Great Western Street

Front Elevation Upgrade

JOB NO:	STATUS CODE:	DRAWING NO:	REV:
3238	S2	340	E

GW-BTP-01-ZZ-DR-A-3238_340.E

Proposed Elevation 1 - Upgrade

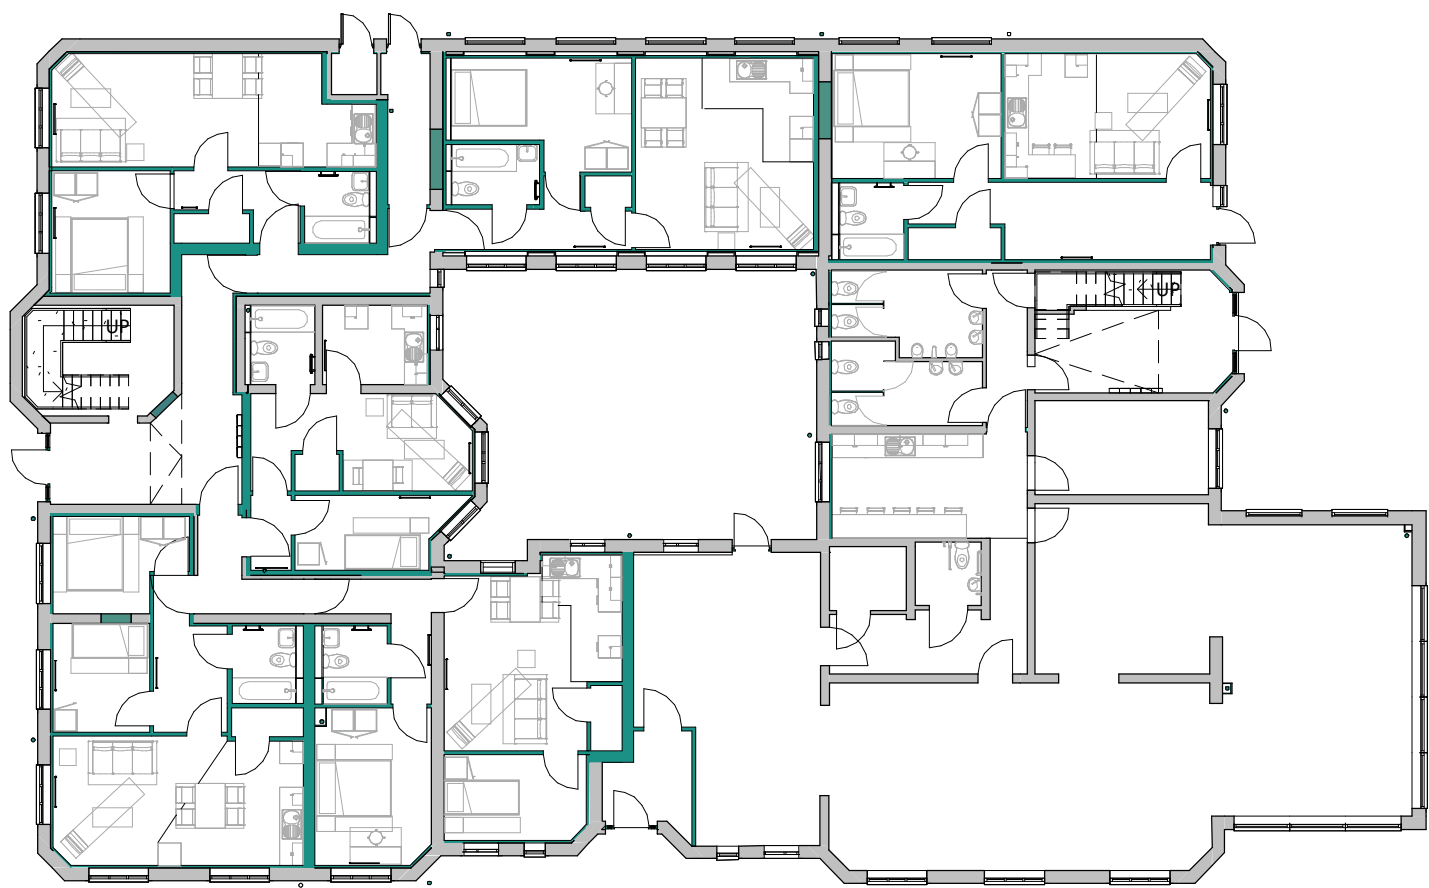
~~Canopy structure~~

~~BradFabs Ltd or similar approved~~
